Subject: UniStar Nuclear Energy, NRC Docket No. 52-016  
Calvert Cliffs Nuclear Power Plant, Unit 3  
Supplemental Response for RAI HS-13

**Supplemental Response for RAI HS-13  
CCNPP Unit 3 Environmental Report**

Figure 4.2-1—{Final Site Grading Plan CCNPP Unit 3}

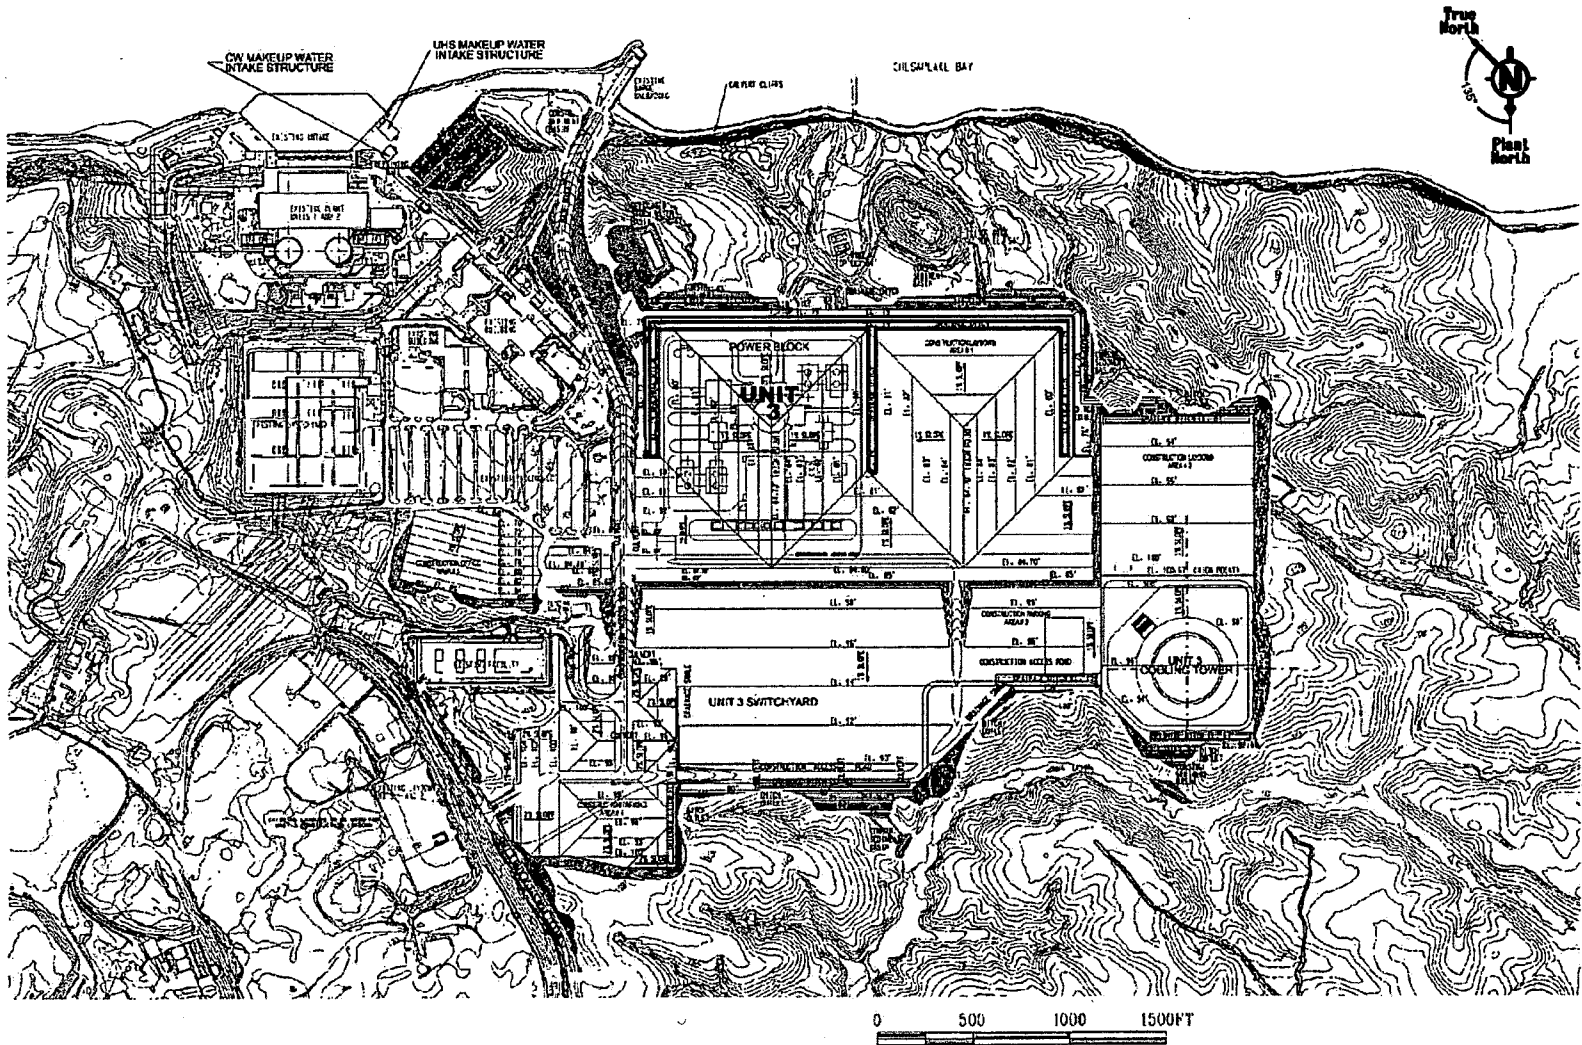
A permanent groundwater dewatering system is not anticipated to be a design feature for the CCNPP Unit 3 facilities. Removal of a portion of the Surficial aquifer during construction may eventually lower the expected depth to groundwater. Surface water controls to minimize precipitation infiltration and the redirection of surface runoff away from the facility area are expected, further minimizing water infiltration to the groundwater system beneath the site. Groundwater elevations will continue to be monitored, and any observed deviations in groundwater elevations potentially impacting the current design basis will be accounted for to design a construction dewatering system, as appropriate (Section 2.3.2.2.11 page 2.3-47). Provide if possible a topographic map with an overlay of the construction foot print and with contours that can be easily read. Describe how the recharge to the Surficial aquifer would be impacted in the short term. Long term is presented in Figures 2.3.2-(24-25). Identify how the seeps and streams would be impacted and how this would impact local wells.

The numerical model of the Surficial aquifer has been revised to evaluate construction impacts to groundwater levels in the vicinity of the power block and stream flow off site in John's Creek. Figure 2.3-86 shows the topography of the post-construction groundwater flow model and Figure 4.2-1 shows the construction footprint of the CCNPP Unit 3 site. Both stream flow and groundwater levels after construction of CCNPP Unit 3 will be dependent upon several factors, including the hydraulic conductivity of the engineered fill material used and the rate of groundwater recharge within the graded area of the site.

The numerical model of the Surficial aquifer has been revised to evaluate construction impacts to groundwater levels in the vicinity of the power block and stream flow off site in John's Creek. Figure 2.3-86 shows the topography of the post-construction groundwater flow model and Figure 4.2-1 shows the construction footprint of the CCNPP Unit 3 site. Both stream flow and groundwater levels after construction of CCNPP Unit 3 will be dependent upon several factors, including the hydraulic conductivity of the engineered fill material used and the rate of groundwater recharge within the graded area of the site.
